Submission to the
House of Representatives Standing Committee on Legal and Constitutional Affairs
on the
Draft Disability (Access to Premises – Buildings) Standards

Max Murray
1 March 2009
(As amended-13 March 2009)

Submission No 39

Figure 1 A90 Accessible Path of Travel

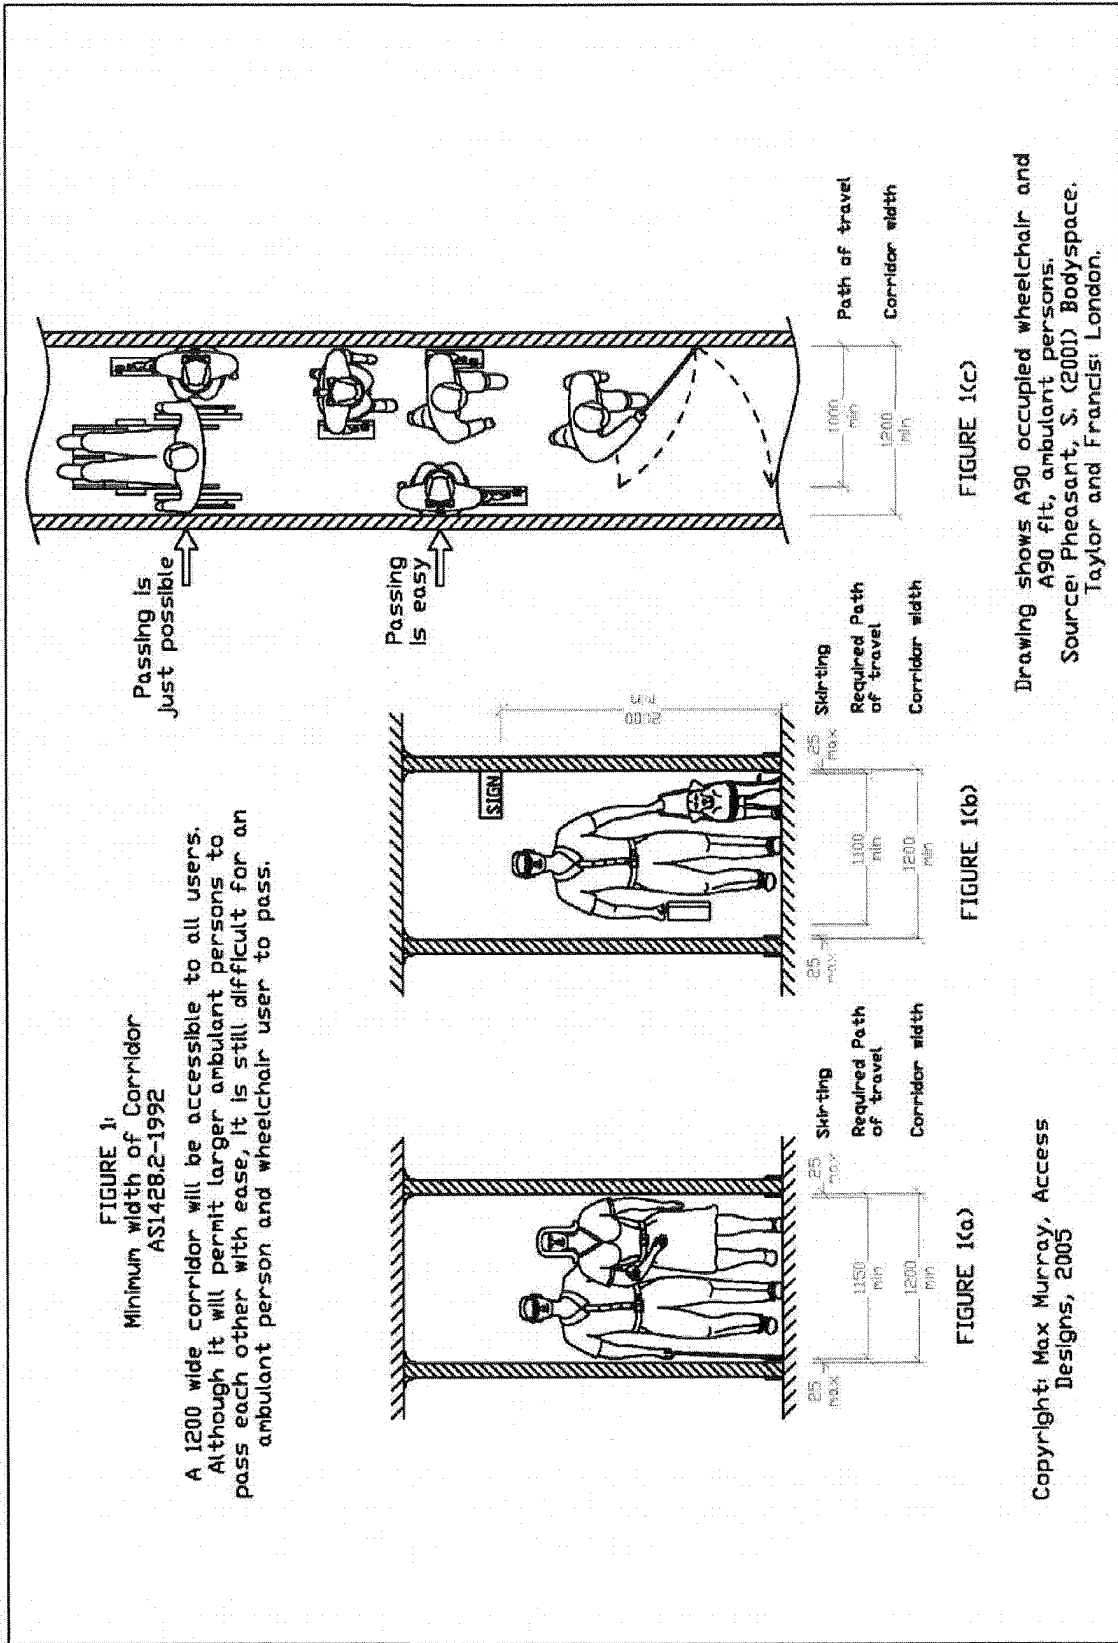
Two drawings (Figure 1 and 2) are submitted to demonstrate the limited space available along an accessible path of travel provided by a 1000mm wide path. The drawings illustrate the inconvenience imposed upon fit, healthy able-bodied persons represented at the upper 90% of the Australian population to pass within a 1000mm wide access path.

Figure 2 A80 Accessible Path of Travel

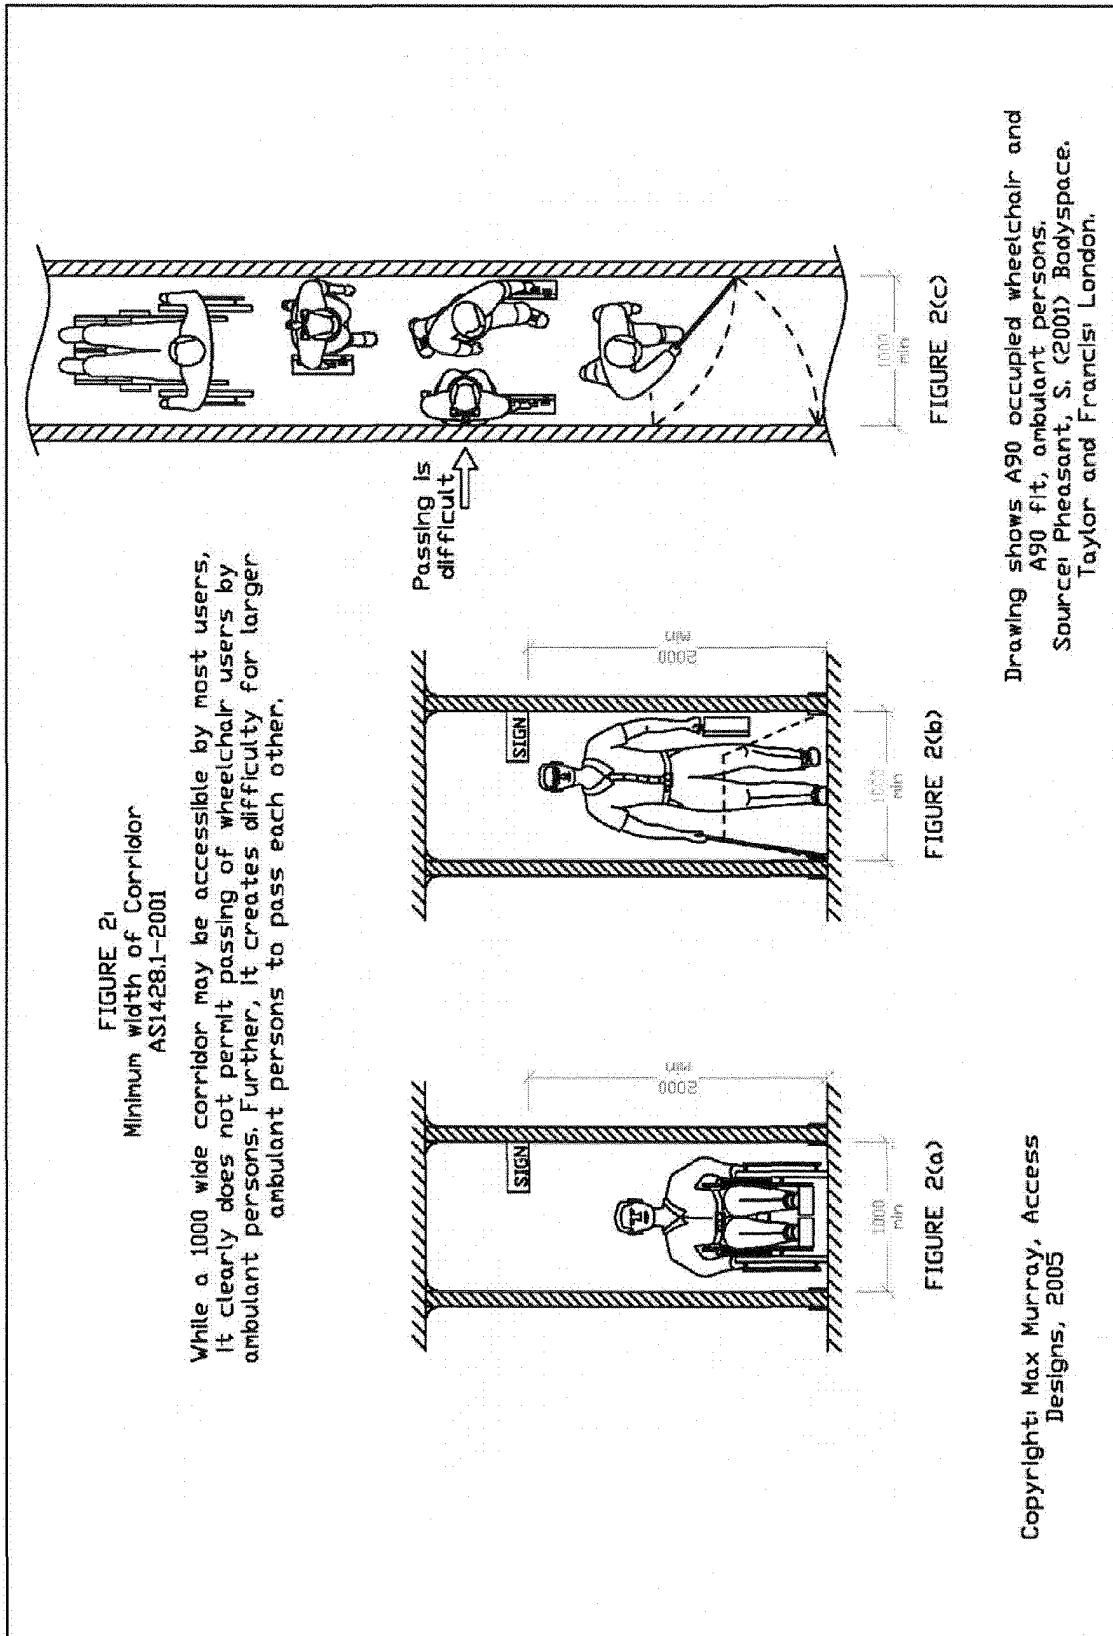
Figure 2 demonstrates the difficulties which result with a 1000mm straight path of travel. Difficulties escalate for people who must use A90 wheelchairs when a 1000mm wide path of travel deviates from straight. There is no Australian research data to support the suggestion for maintaining a 1000mm wide path of travel through turns up to and including 60 degrees.

Figure 3 Inaccessibility at interface between A80 and A90 Spaces

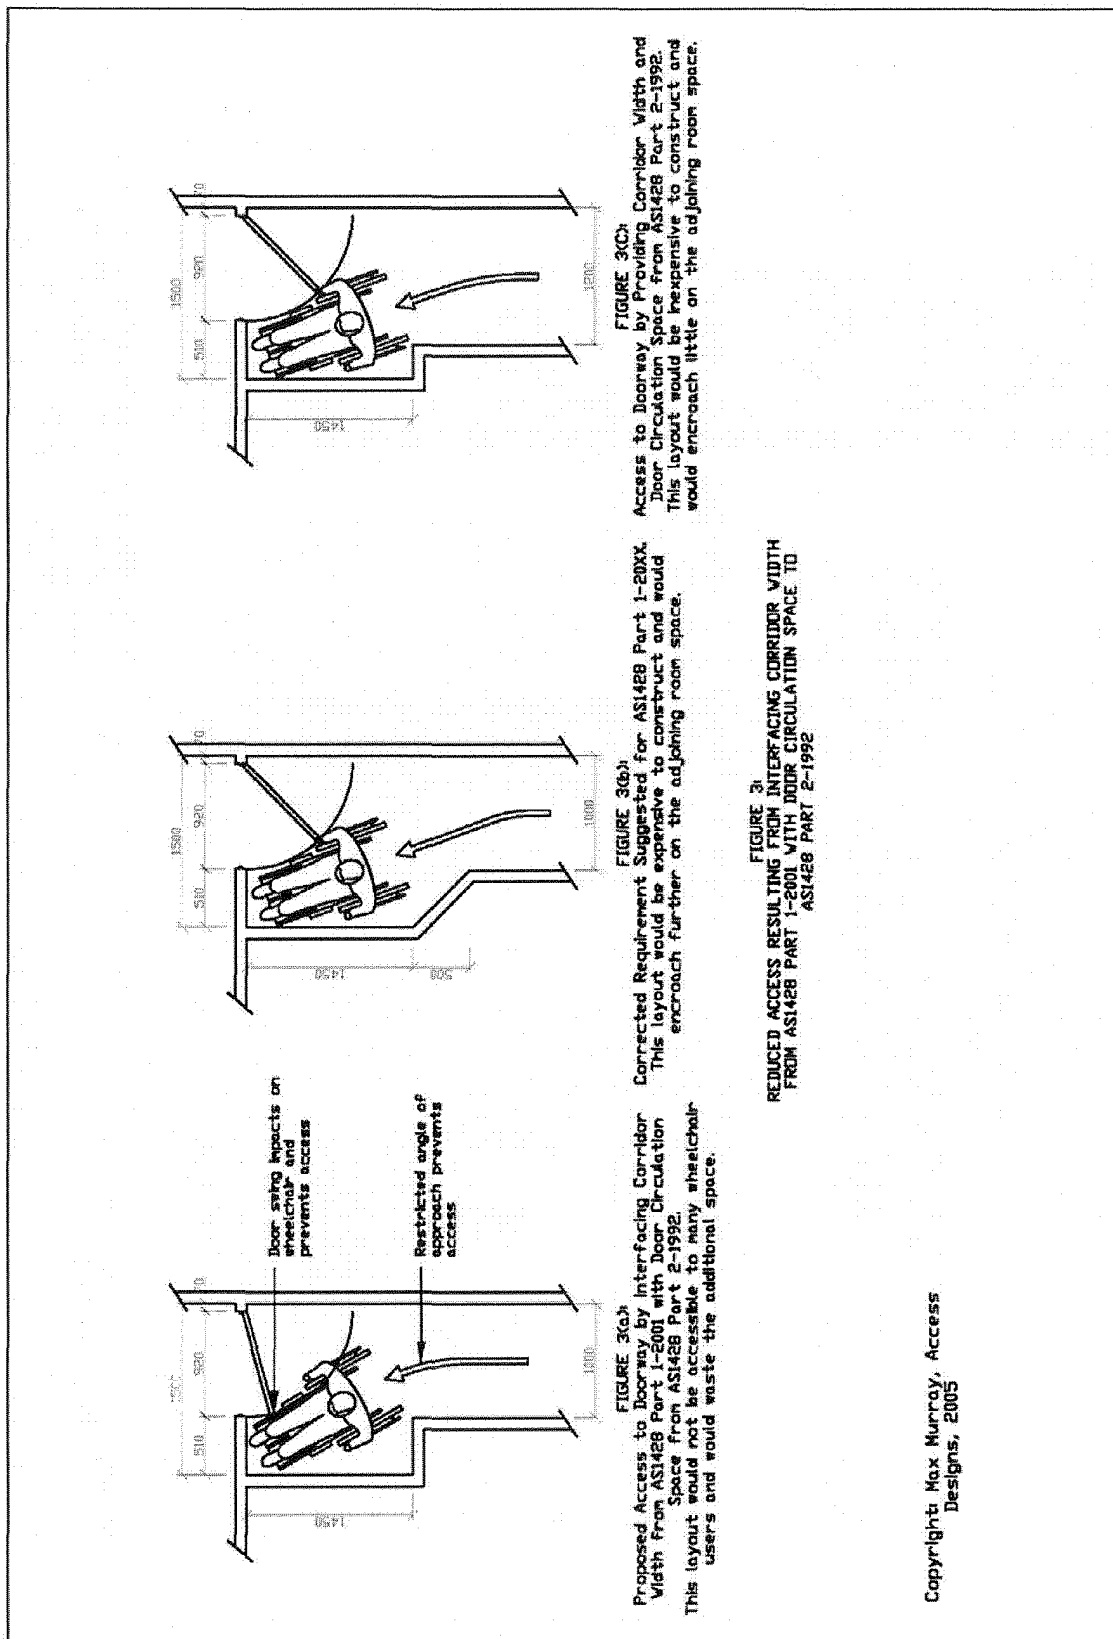
A third drawing (Figure 3) is submitted to demonstrate the conflict which results when A80 dimensions interface with A90 dimensions. Figure 3 illustrates the inaccessibility which results at a doorway at the end of a corridor preventing the wheelchair user avoiding the swing of the door. A similar situation is created with doorways leading off a corridor. Such conflict along an accessible path of travel can only be resolved by truncation of the internal corner by the required distance in both directions. This is a necessary expensive waste of space.

Figure 6 Relative Dimensions of A80 and A90 Occupied Wheelchair

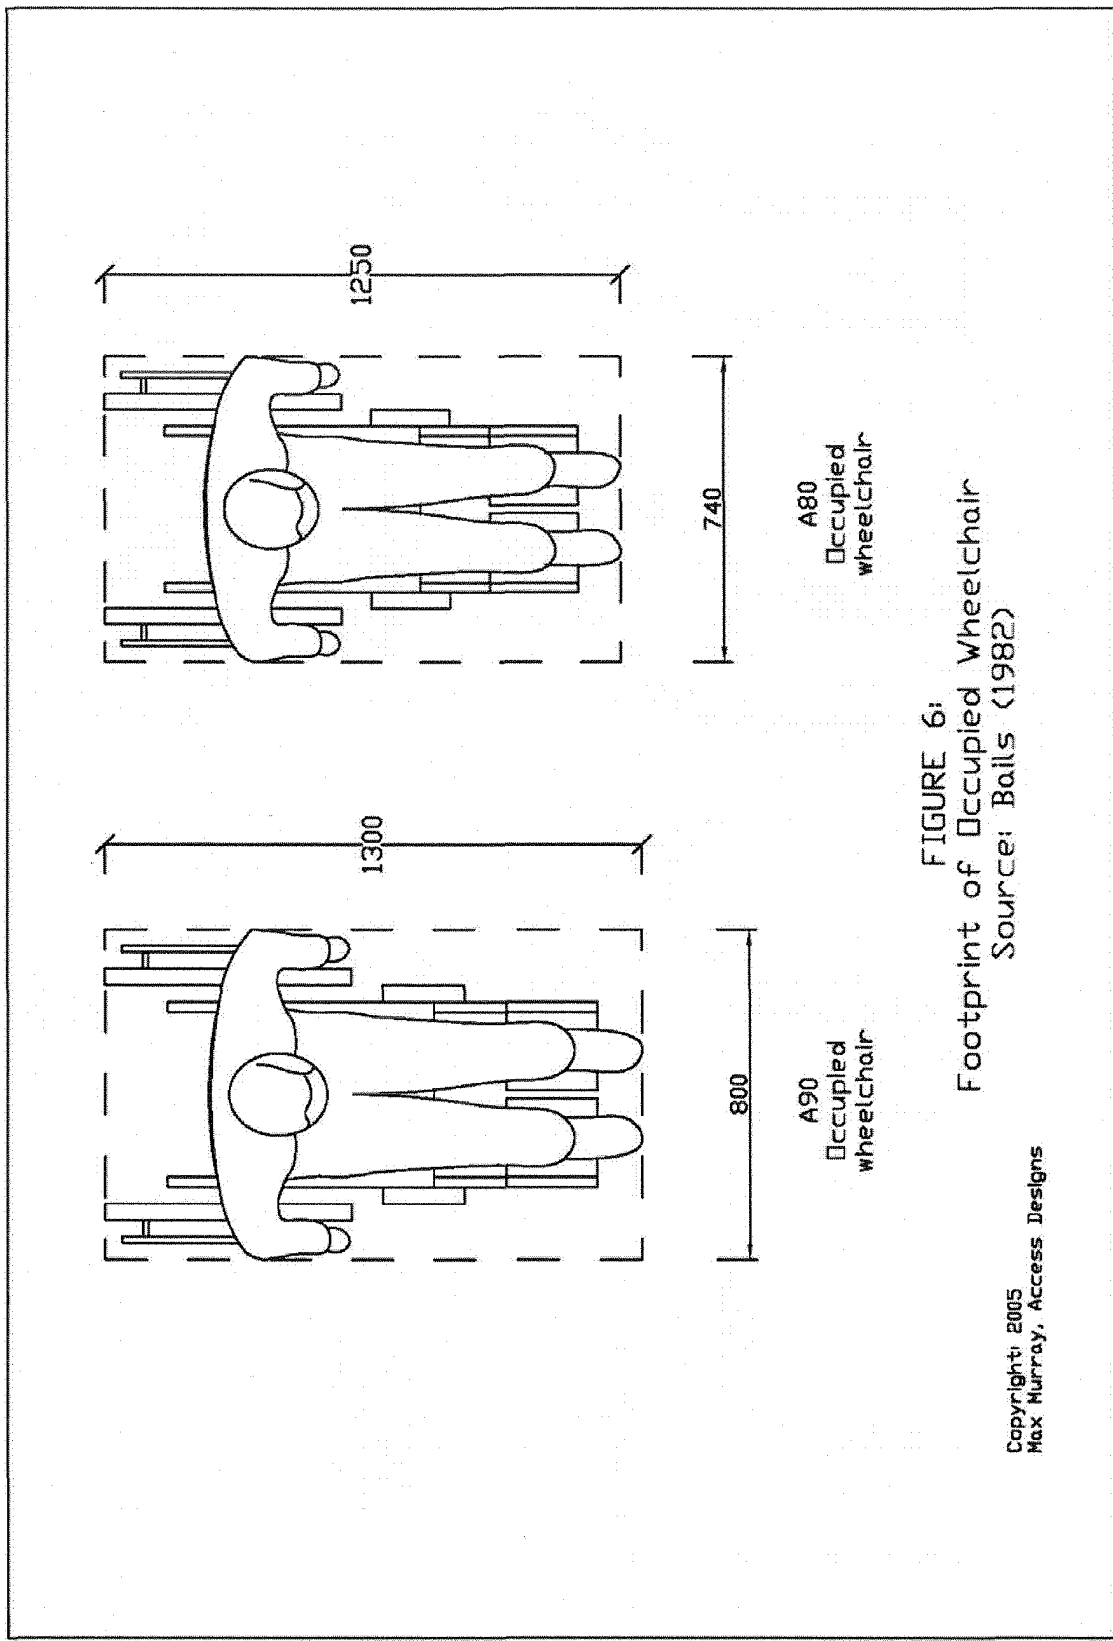
The research by J Bails 1982 clearly defined two size wheelchairs (Figure 6), namely the A80 and the A90 wheelchair (although the dimensions for the A90 wheelchair have not been provided). It is known from later research (Seeger 1994; Hunarch unpublished data (obtained under FOI)) that the 800mm x 1300mm space no longer accommodates the A90 wheelchair observed by this recent research. The conflict at the interface of A80 and A90 requirements prescribed by AS1428-1 and AS1428-2 will discriminate further against those members of the Australian population which use a current A90 wheelchair.

Figure 7 Corner space required to Accommodate an A90 Occupied Wheelchair at a Change in Direction

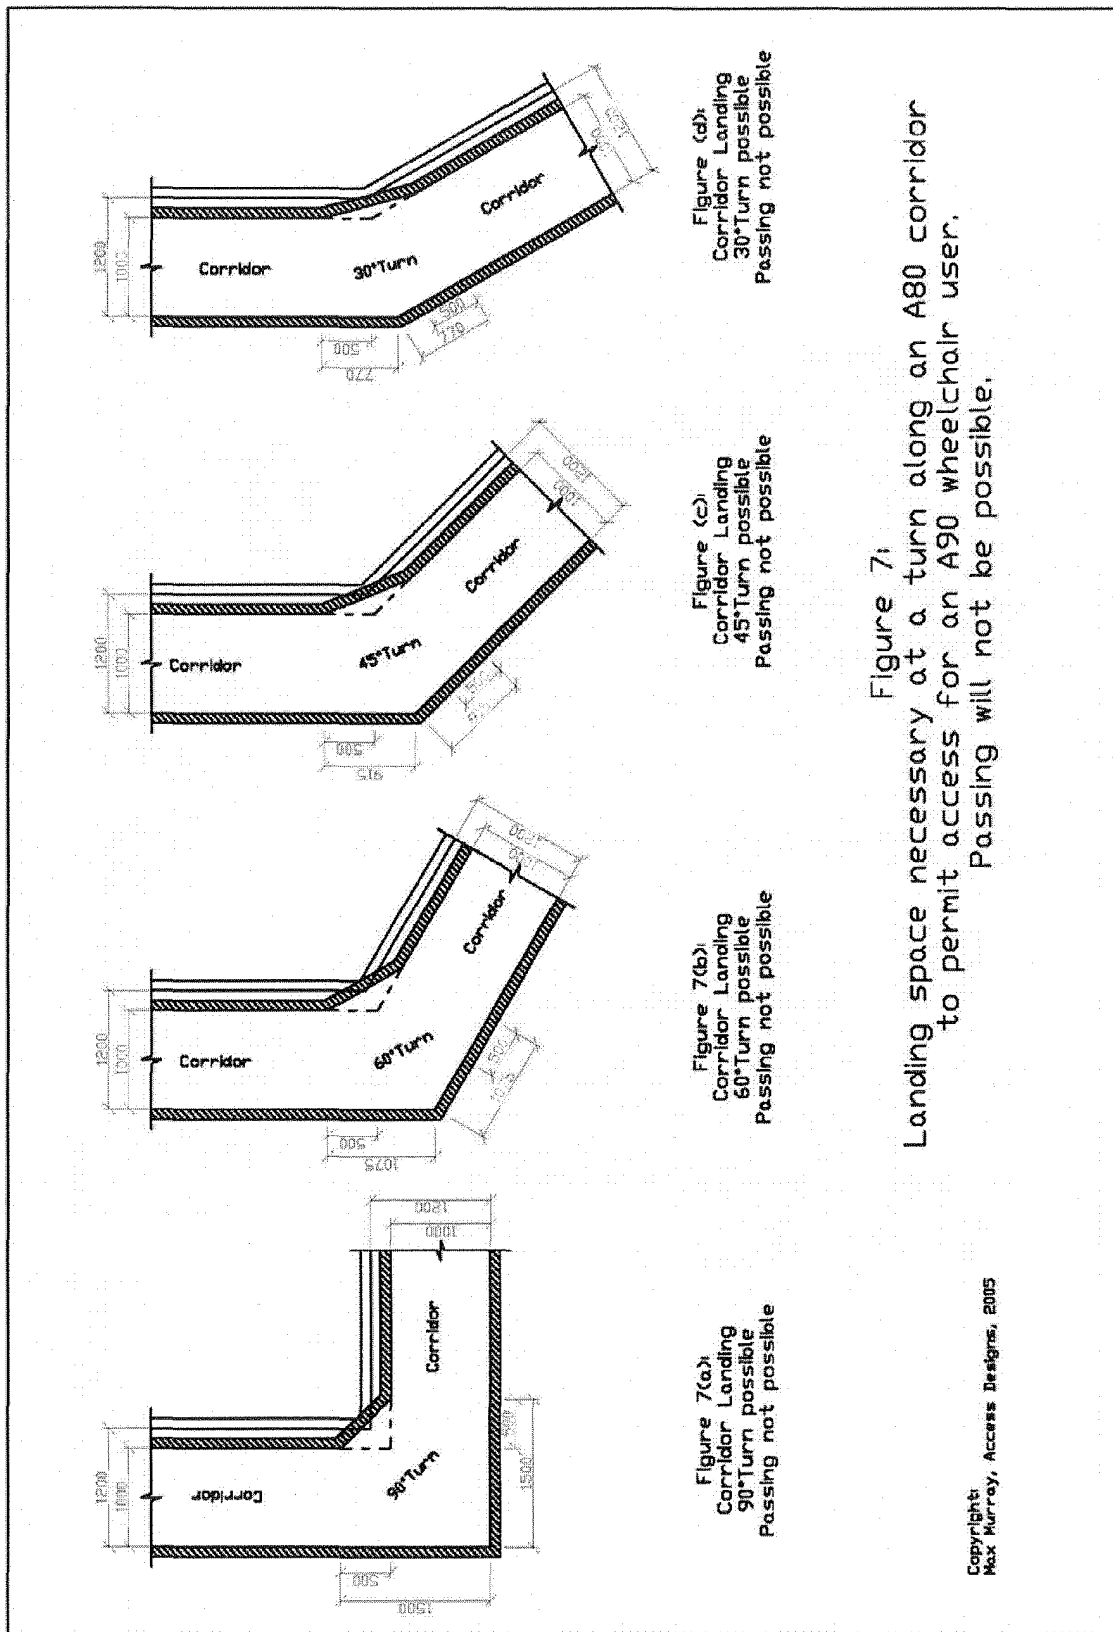
Whenever an access path diverts from straight by any degree, the needs of the A90 occupied wheelchair must be accommodated. Figure 7 illustrates how this can be achieved by requiring the inside corner to be truncated by 500mm in both directions.

- It is recommended that whenever an access path diverts from straight by any degree, the needs of the A90 occupied wheelchair must be accommodated by requiring the inside corner to be truncated by a minimum of 500mm in both directions.
